HumeLink

Amendment Report

Rev 0

May 2024

Figure 3-5a: Nominated access tracks

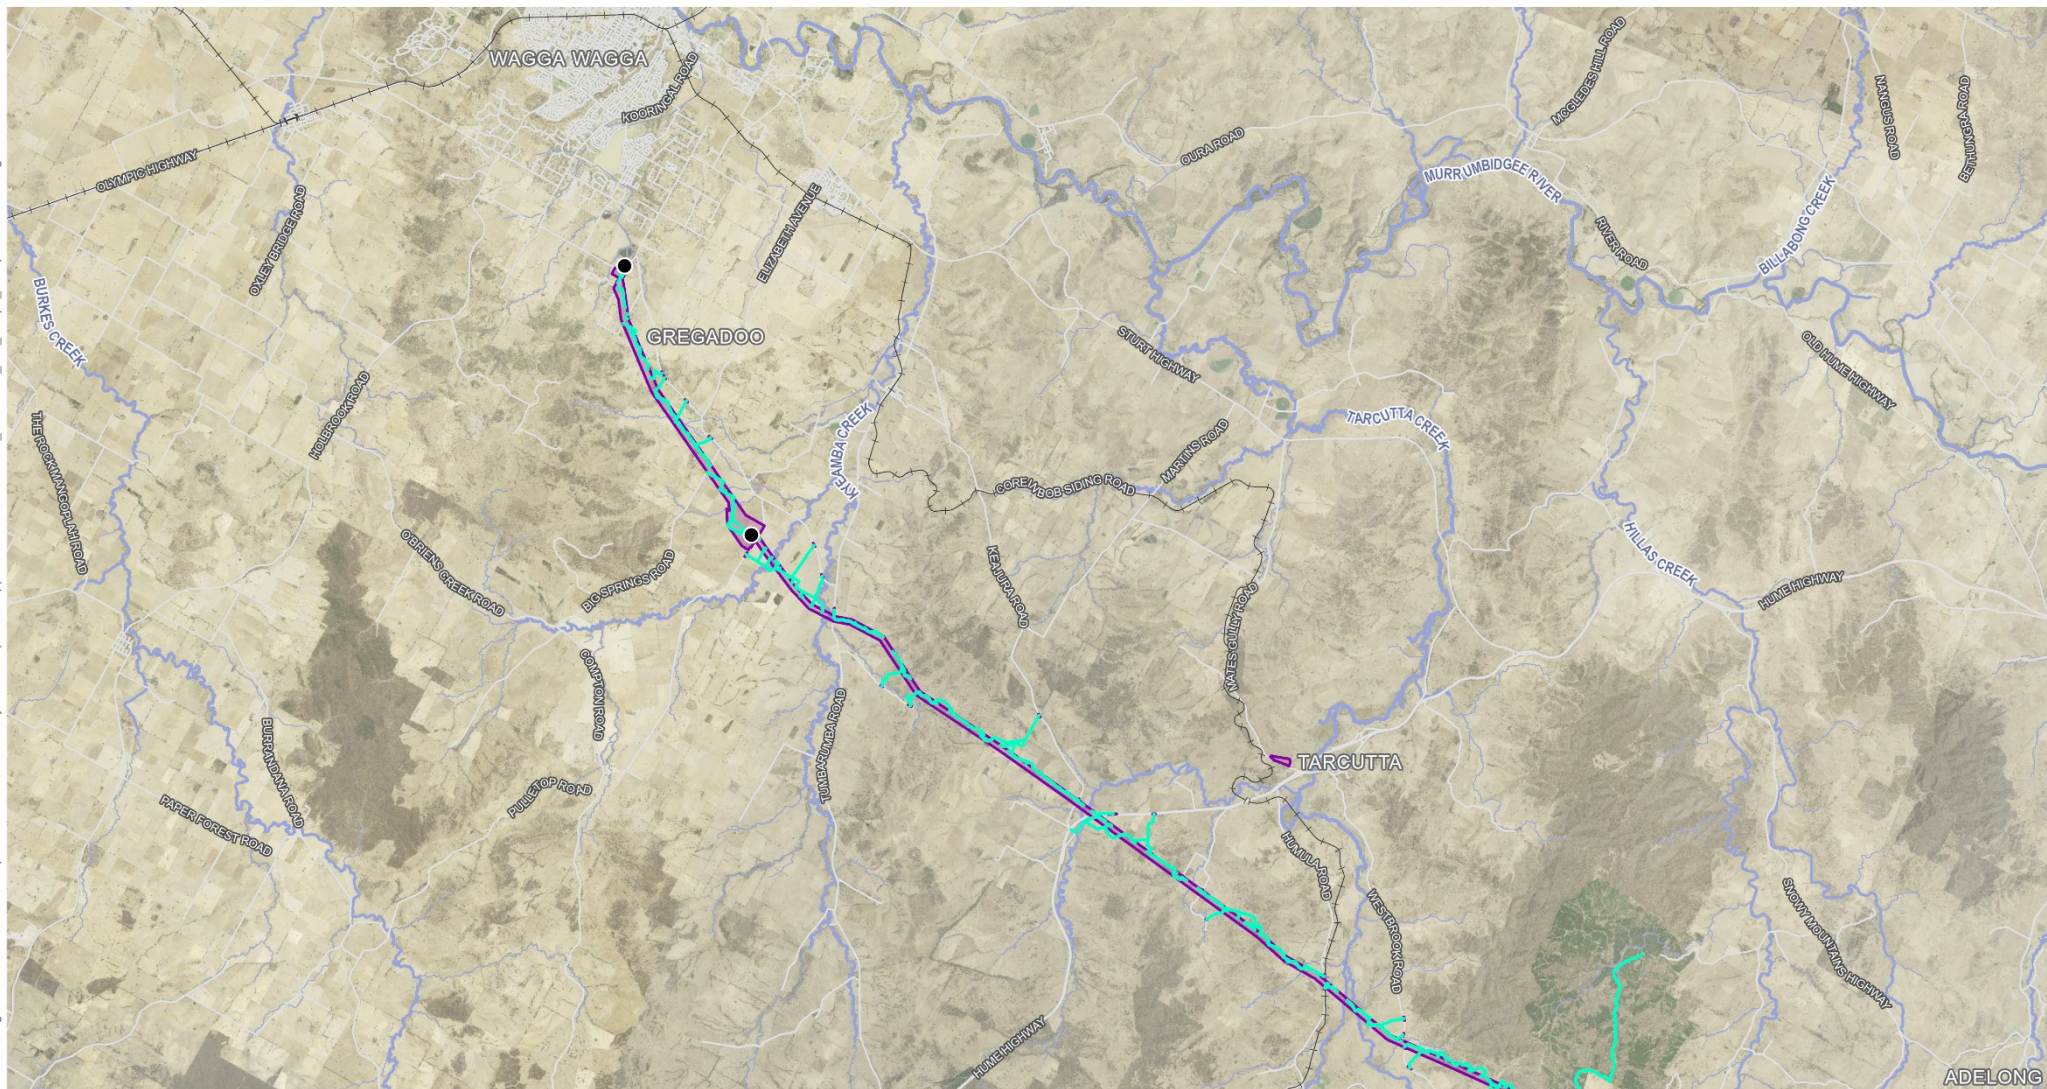
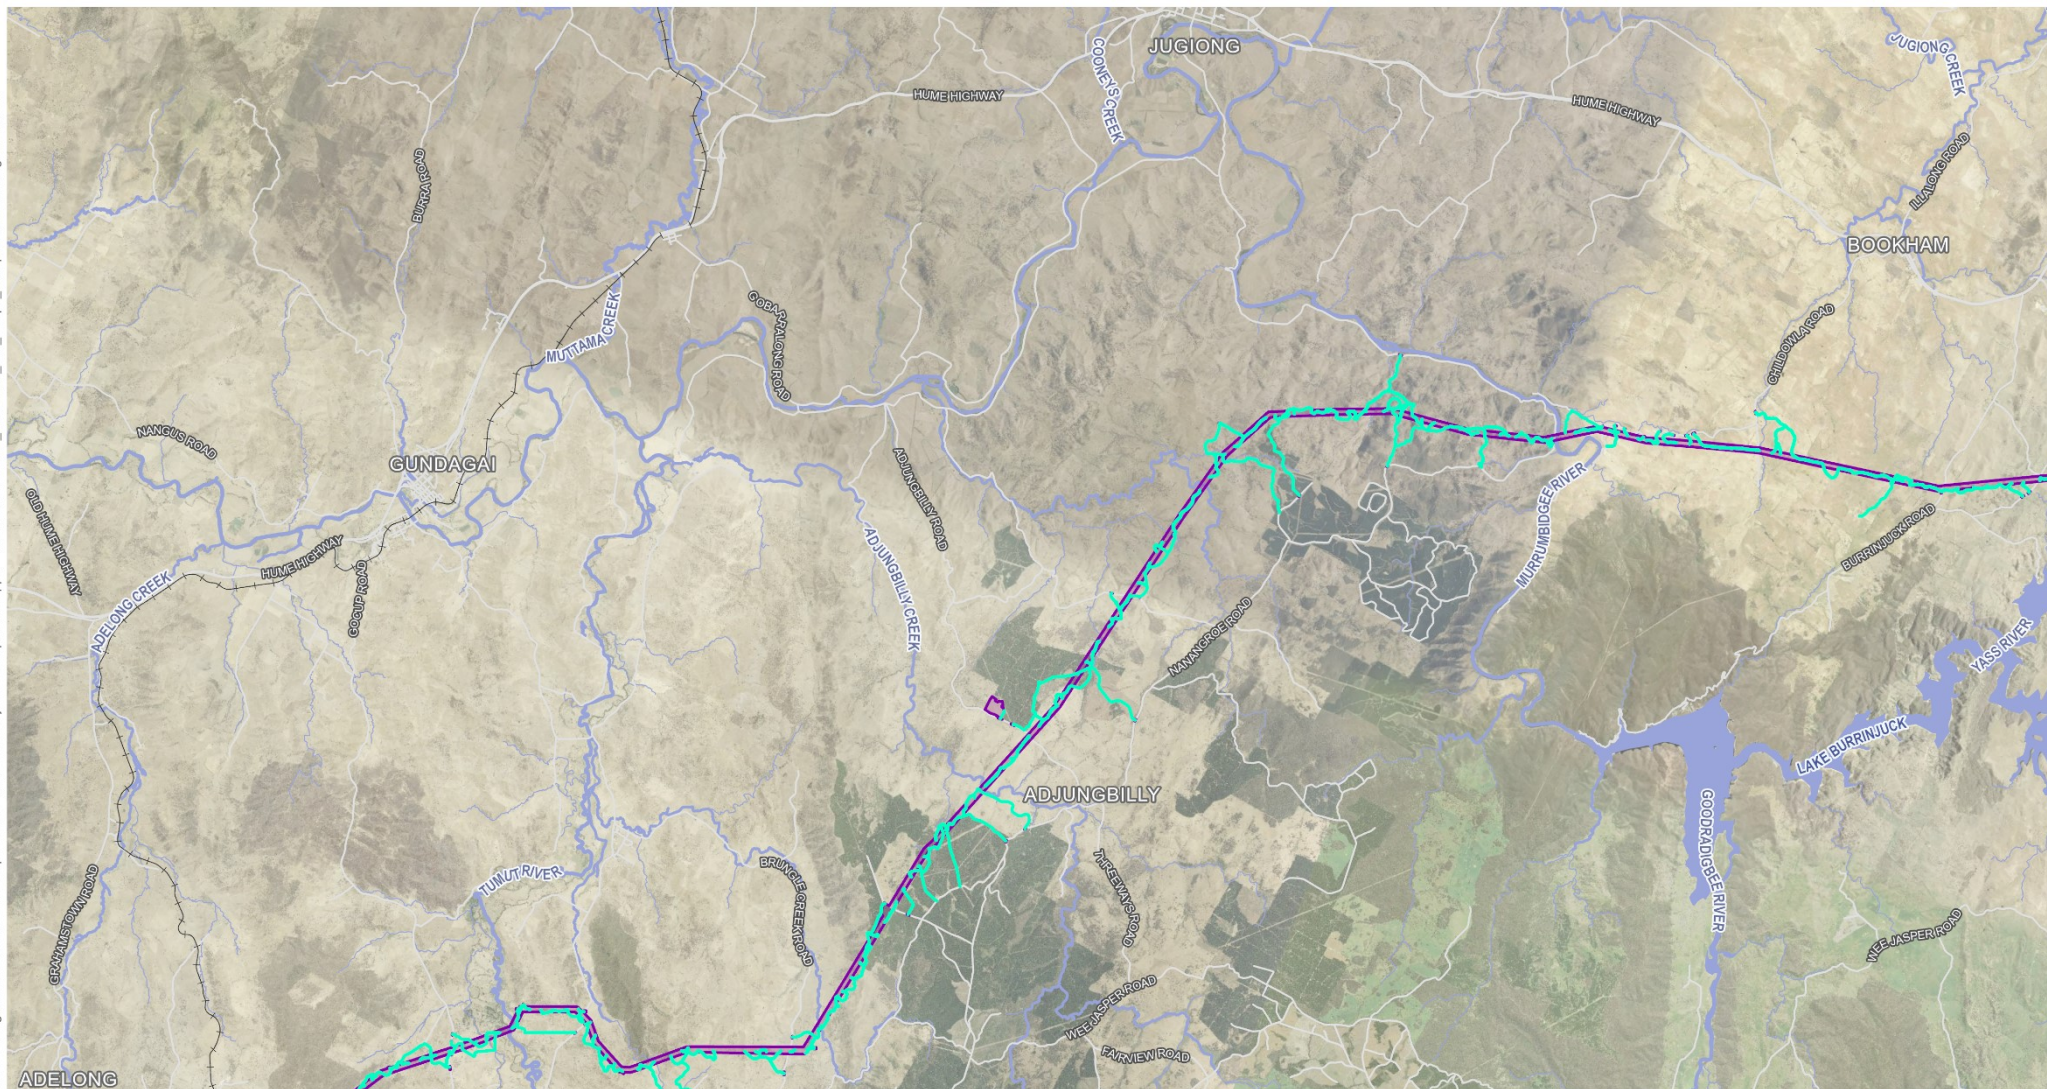
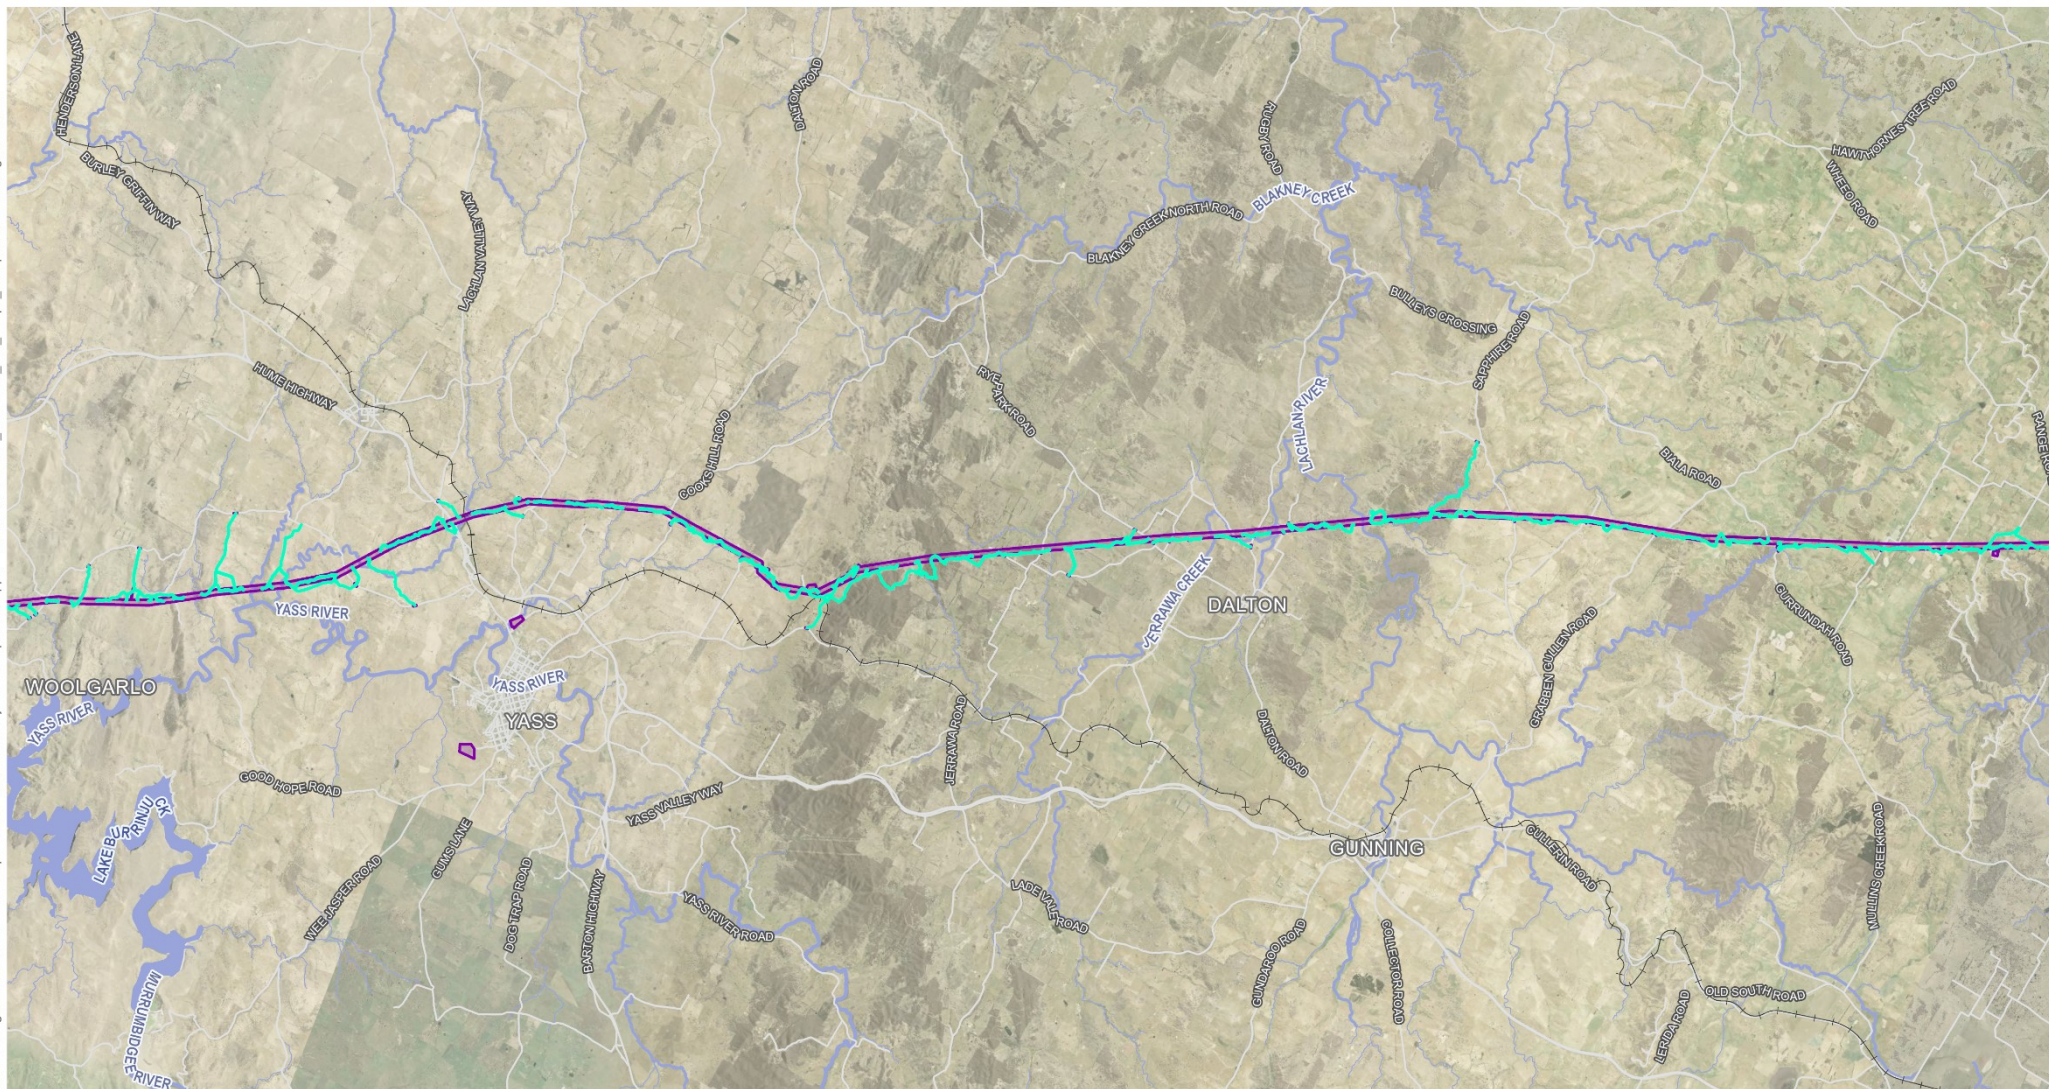
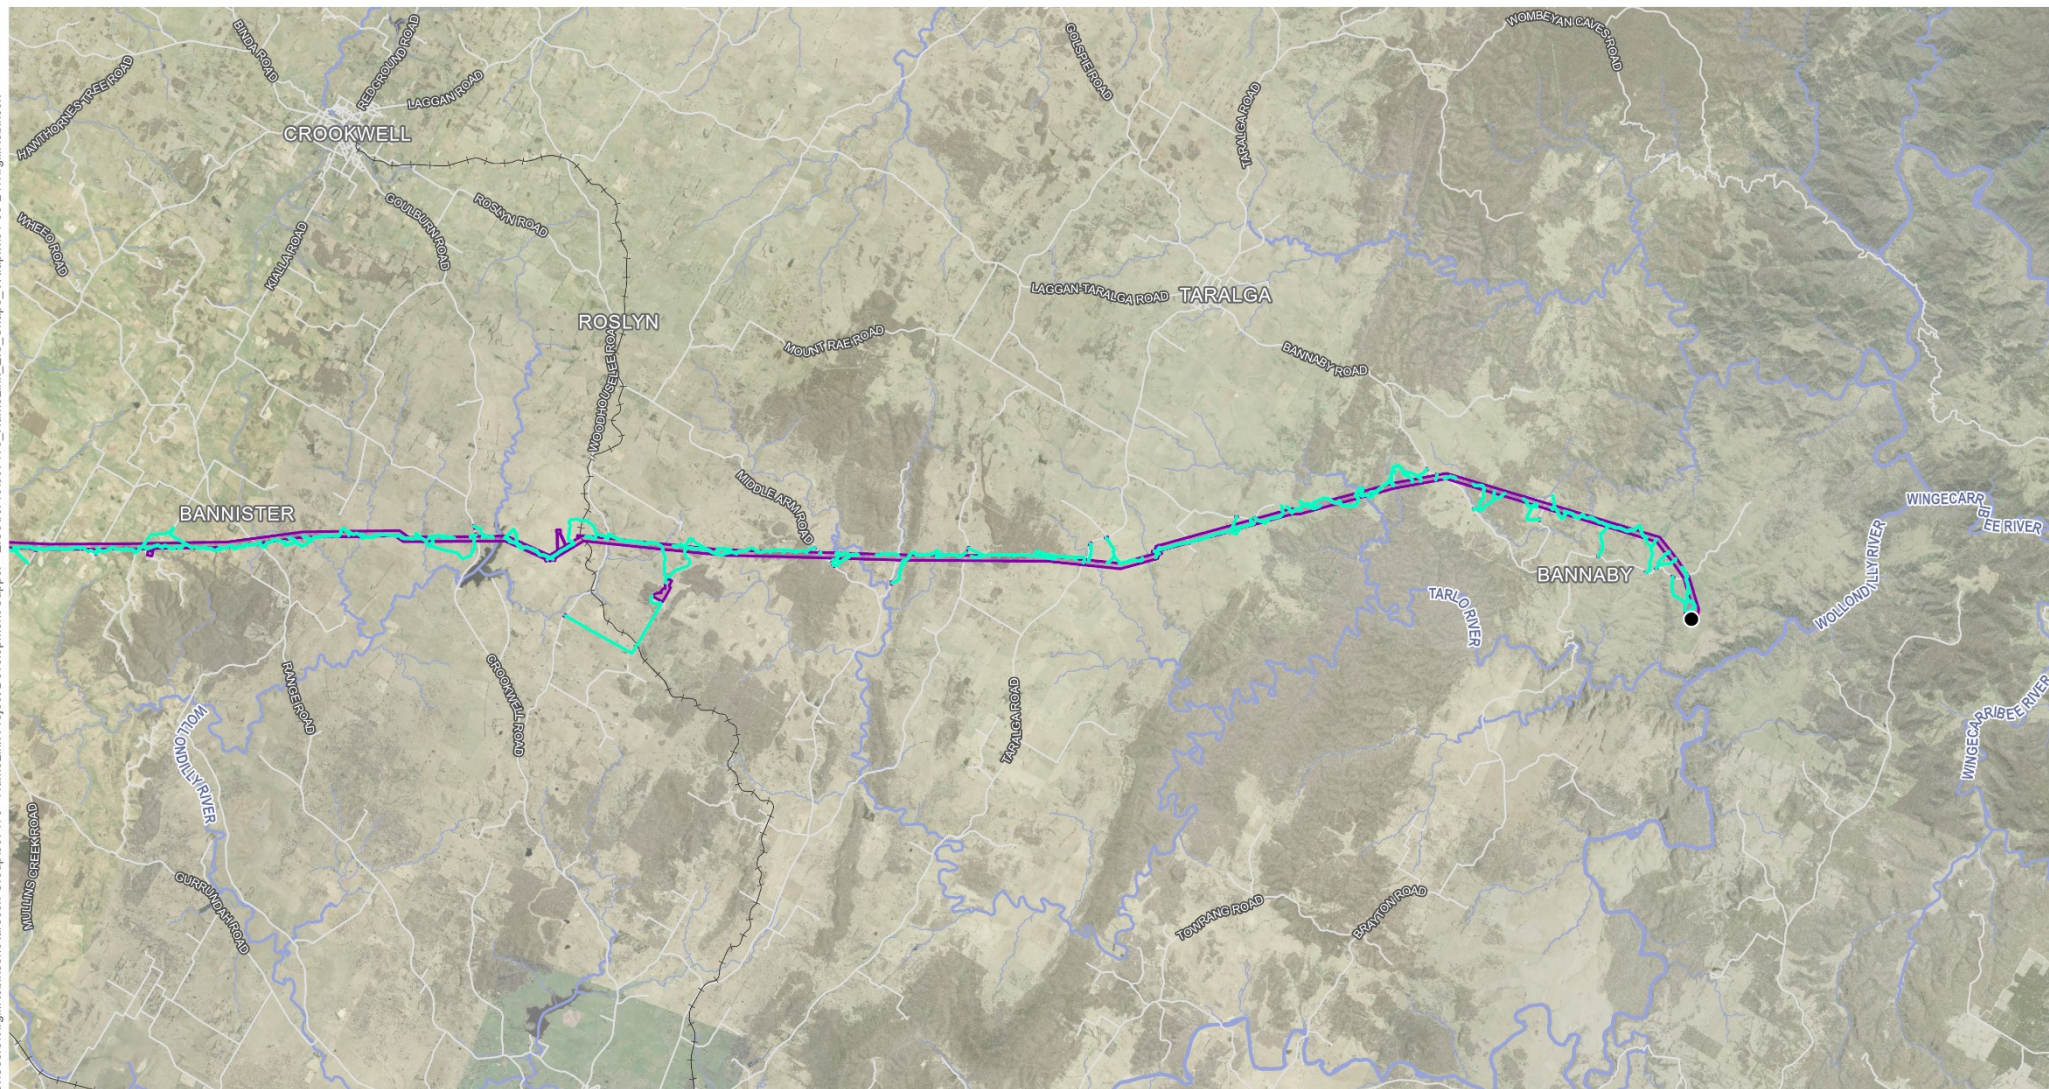
Table 3-5 describes the expected work likely to be involved to make the nominated access tracks suitable for heavy vehicle movements. The full extent of work would be confirmed following further review and survey of the nominated access tracks. Figure 3-5 shows the location of the nominated access tracks along the project footprint.

New tracks	<p>The locations of new access tracks have generally been selected in consultation with affected landowners to minimise property impacts, including running the track along fence lines, using movement paths preferred by landowners, and going through existing property gates.</p> <p>Establishing the new tracks would typically include earthworks, grading, drainage work and construction of waterway crossings. Fill material may be imported to provide a suitable capping material.</p> <p>To establish the new tracks, vegetation clearing or pruning/trimming may be required. The total clearing width would generally be up to 10 m, with some limited areas (eg steep terrain) requiring a clearing width of up to 20 m for batters.</p>
